2.4 Core Cooling Systems

The information in this section of the reference ABWR DCD, including all subsections, tables, and figures, is incorporated by reference with the following departures.

STD DEP T1 2.4-1 (Figure 2.4.1a, Table 2.4.1)

STD DEP T1 2.4-2 (Figure 2.4.3)

Figure 2.4.1a Residual Heat Removal System (RHR-A)

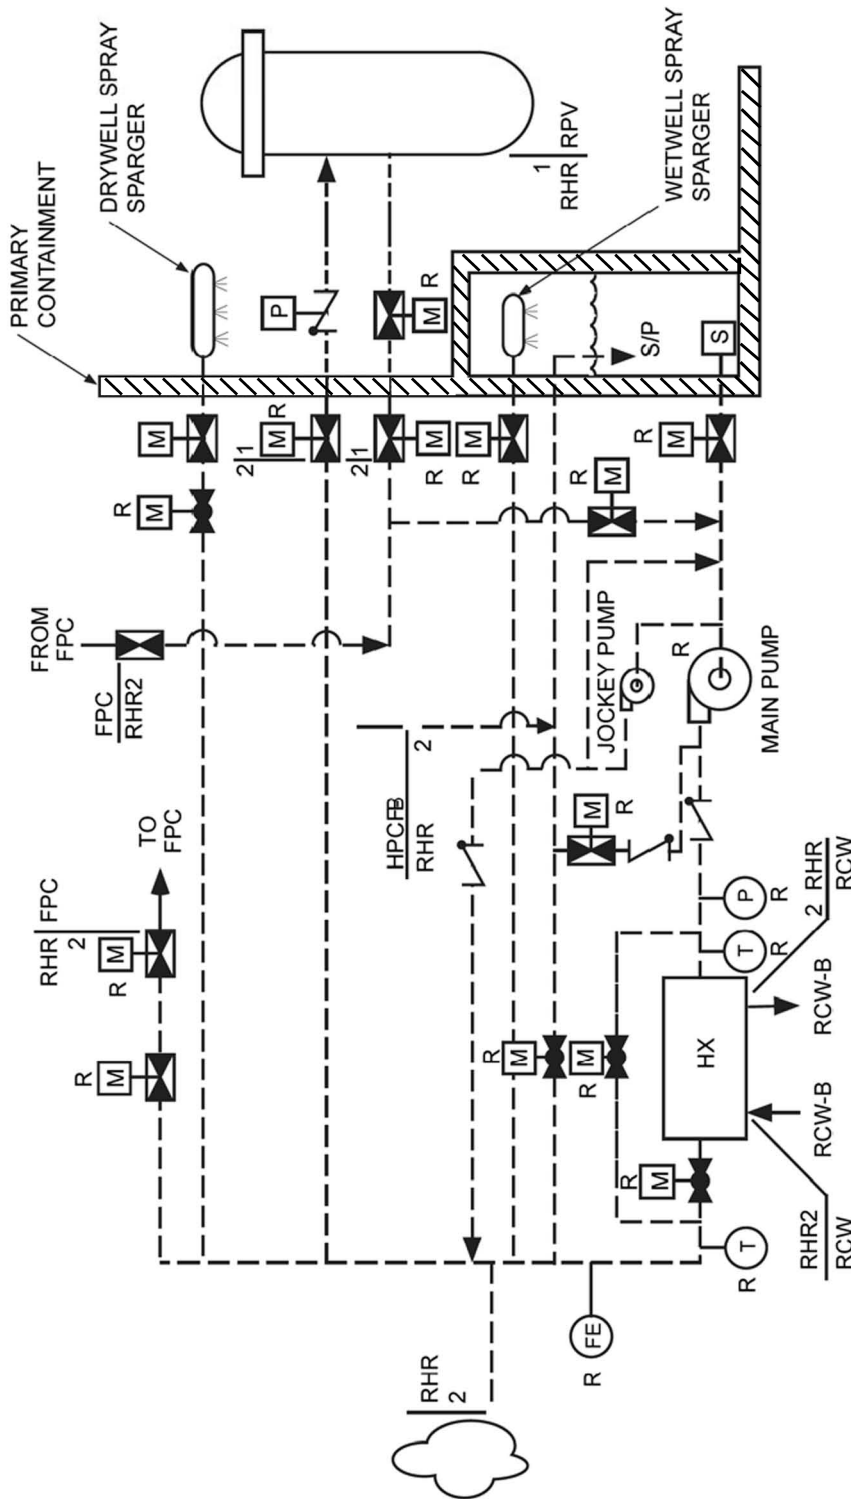
STD DEP T1 2.4-1

The augmented fuel pool cooling mode of the RHR System (Divisions A, B and C) can supplement the Fuel Pool Cooling (FPC) System as follows: (1) directly cooling the fuel pool by circulation fuel pool water through the RHR heat exchanger and returning it to the fuel pool; and (2) while providing shutdown cooling during refueling operations, return the cooled RHR shutdown cooling flow to the fuel pool. Also, this mode provides for fuel pool emergency makeup capability by permitting the RHR pumps (Divisions A, B and C) to transfer suppression pool water to the fuel pool. This mode is accomplished manually by control of individual system components. In the augmented fuel pool cooling mode, the RHR tube side heat exchanger flow rate for Divisions A, B or C is no less than 350 m³/h.

The piping and components outside the shutdown cooling suction line containment isolation valves and outside the suppression pool containment isolation valves, and upstream of the suction side of the pump with all its branches have a design pressure of 2.82 MPaG for intersystem LOCA (ISLOCA) conditions. Refer to Figures 2.4.1a, 2.4.1b, and 2.4.1c. ~~For RHR A, the upgraded branch lines from the main pump suction include the path to and including the suppression pool suction valve, the path to the shutdown cooling outboard containment isolation valve, and the path to the jockey pump's discharge check valve including the jockey pump's bypass return line. For RHR B and C, the upgraded branch lines include all the paths listed for RHR A plus the path to (and including the valve) the Fuel Pool Cooling System that branches off the shutdown cooling suction line, titled "From FPC."~~ For RHR A and B, the upgraded branch lines from the main pump suction include the path to and including the suppression pool suction valve, the path to the shutdown cooling outboard

containment isolation valve, the path to the jockey pump's discharge valve including the jockey pump's bypass line and the path to the (and including the valve) the Fuel Pool Cooling System that branches off the shutdown cooling suction, titled, "From FPC." For RHR-C, the upgraded branch lines include all the paths listed for RHR-A and B plus the pipeline and valves that are part of the AC independent water addition mode that extends from the noncode boundary indicated by "NNS" to the "external connection" outside the "reactor building" and to the Fire Protection System interface indicated by "FP."

Figure 2.4.1b Residual Heat Removal System (RHR-B)

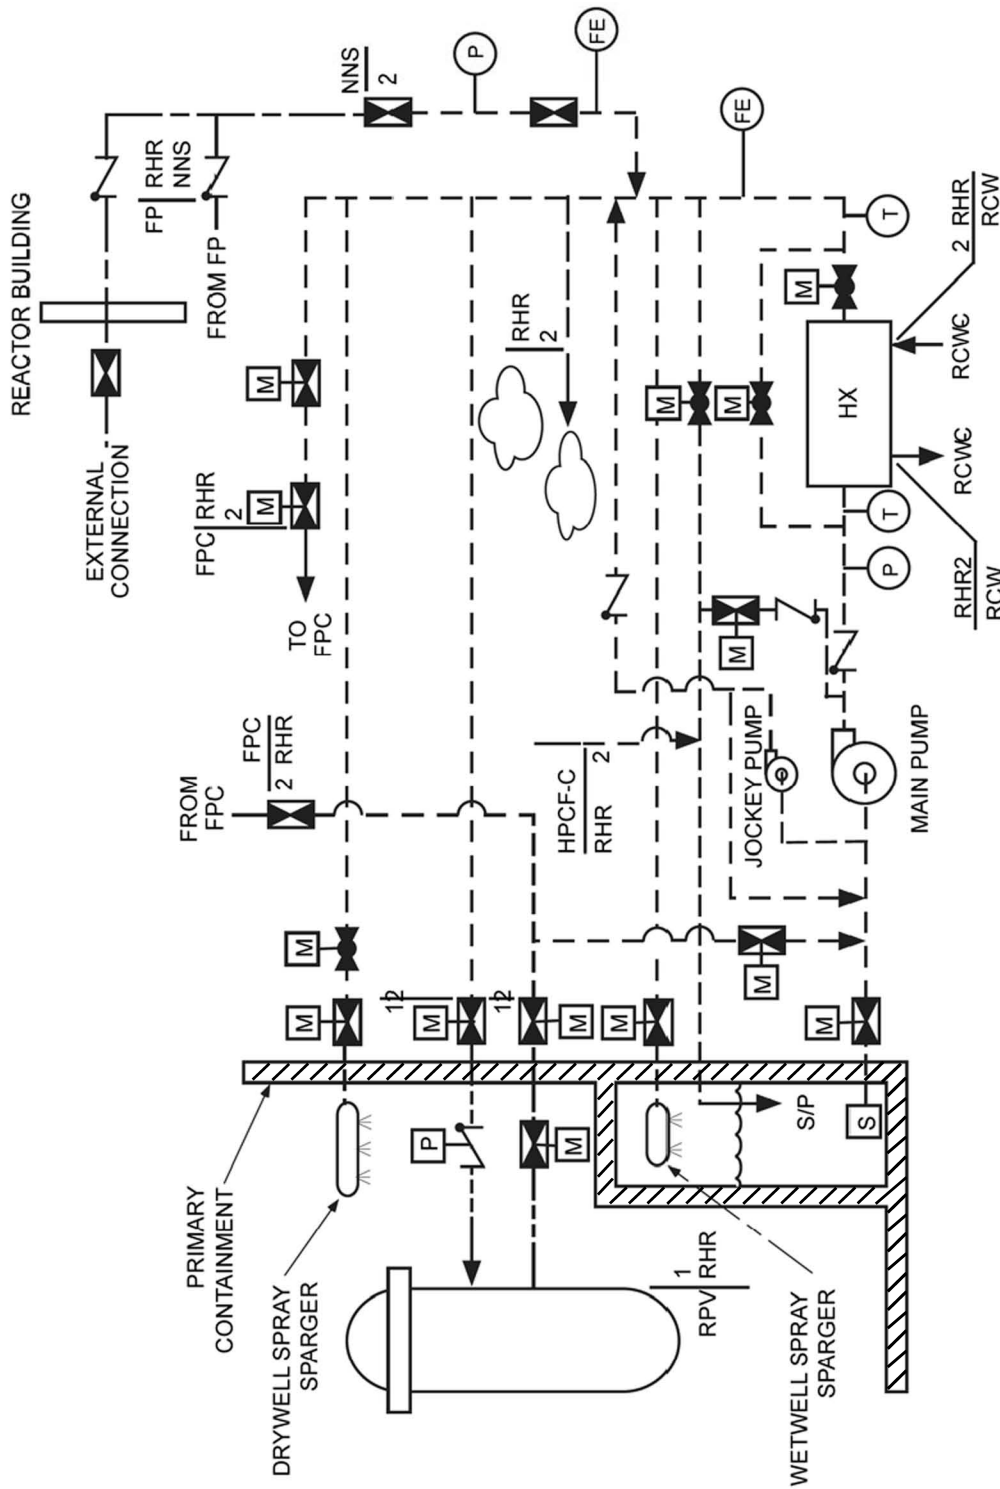
STD DEP T1 2.14-1 (Figure 2.4.1b, Figure 2.4.1c, Figure 2.4.3)

Design Commitment	Inspections, Tests, Analyses and Acceptance Criteria	Acceptance Criteria
<p>7. In the augmented fuel pool cooling mode, the RHR tube side heat exchanger flow rate for Divisions B-6-C is no less than 350 m³/h (heat exchanger heat removal capacity in this mode is bounded by suppression pool cooling requirements).</p>	<p>7. Tests will be performed to determine system flow rate through each heat exchanger in the augmented fuel pool cooling mode. Inspections and analyses shall be performed to verify that the augmented fuel pool cooling mode is bounded by suppression pool cooling requirements.</p>	<p>7. The RHR tube side heat exchanger flow rate is greater than or equal to 350 m³/h in the augmented fuel pool cooling mode. Heat exchanger heat removal capacity in this mode is bounded by suppression pool cooling requirements.</p>

Figure 2.4.3 Leak Detection and Isolation System Interface Diagram

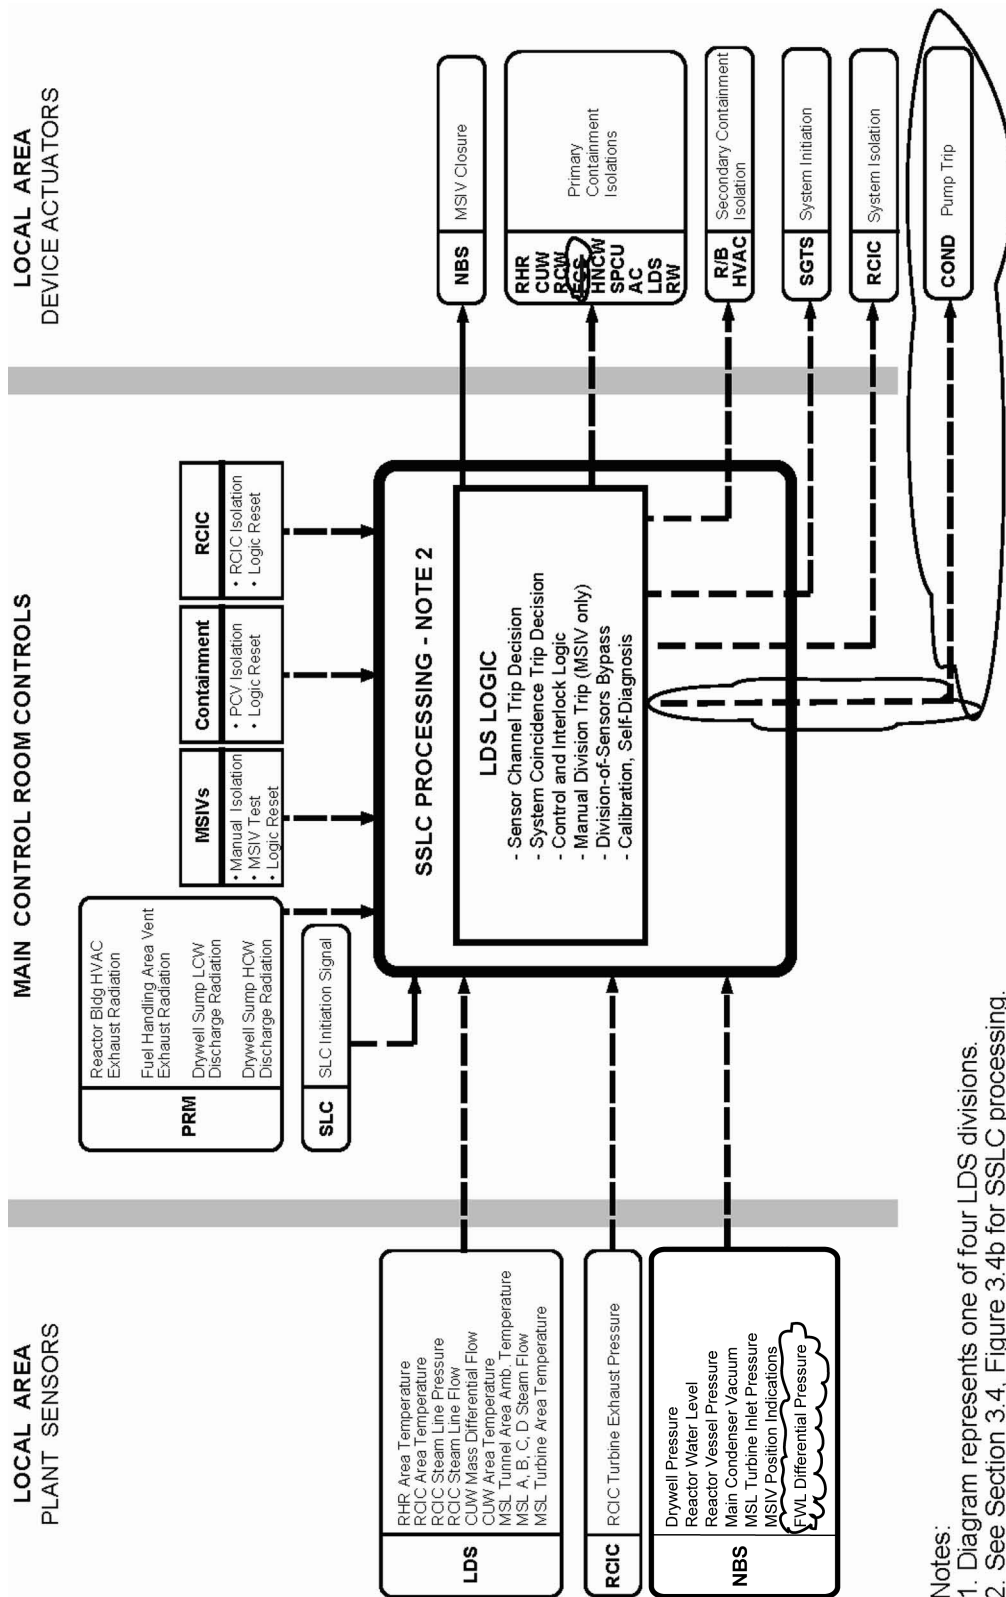
STD DEP T1 2.4-2 (Leak Detection System), Figure 2.4.3

STD DEP T1 2.14-1 (FCS, Figure 2.4.3)

- (9) *Isolation of the Suppression Pool Cleanup (SPCU) System on a signal indicating high drywell pressure or low reactor water level.*
- ~~(10) *Isolation of the Flammability Control System (FCS) on a signal indicating high drywell pressure or low reactor water level.*~~

- (10) ~~(11)~~ *Isolation of the drywell sump low conductivity waste (LCW) and high conductivity waste (HCW) discharge lines on a signal indicating high drywell pressure or low reactor water level. Also, each discharge line is individually isolated on a signal indicating high radioactivity in the discharged liquid waste; only one channel is used for this function.*

- (11) ~~(12)~~ *Isolation of the LDS fission products monitor drywell sample and return lines on a signal indicating high drywell pressure or low reactor water level.*

- (12) ~~(13)~~ *The LDS provides to the neutron monitoring system a signal indicating a high drywell pressure or low reactor water level.*
- (13) *The LDS provides a trip of the condensate pumps on signals that indicate high drywell pressure and high differential pressure between the feedwater lines.*
